SUBJECT: MEETING WITH UNC, INC. (UNC) TO DISCUSS DECOMMISSIONING PLAN

UNC
NAVAL PRODUCTS
DECOMMISSIONING

REPLY TO NRC COMMENTS DATED 1-17-91

FIGURE 2.2
UNC NAVAL PRODUCTS
DECOMMISSIONING & DECONTAMINATION ORGANIZATION CHART

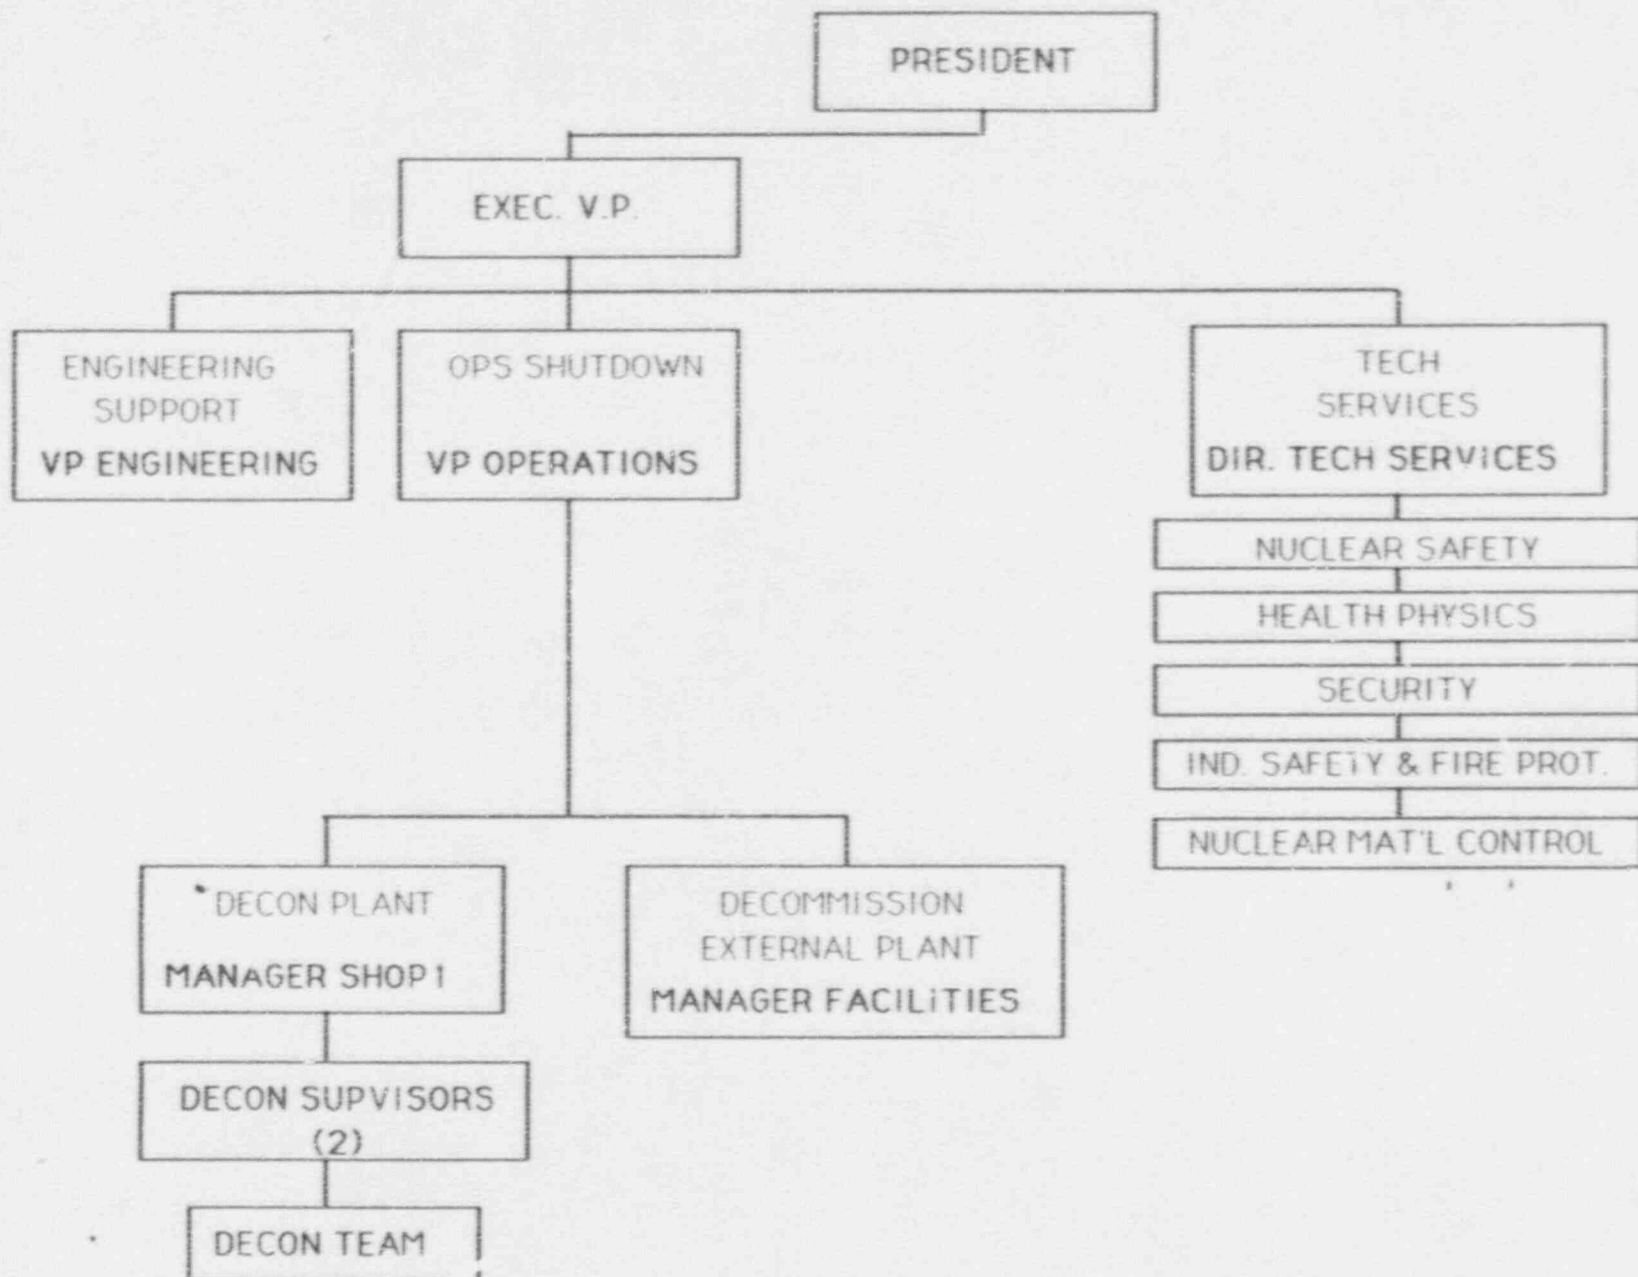
5. NRC Comment⁷ Section 2.2 should identify by title, function, and minimum qualifications the positions responsible for decommissioning.

The organization structure is shown in Figure 2.2. Functional responsibilities are as specified in Sections 2.1, 2.2 and 2.3 of SNM-368. Qualifications for NIS personnel, having safety responsibilities under this license are specified in Section 2.2. Consistent with all licensed operations, NIS performs safety evaluations for all tasks involving radioactive and hazardous materials, and assures that all tools and materials leaving the site meet release limits.
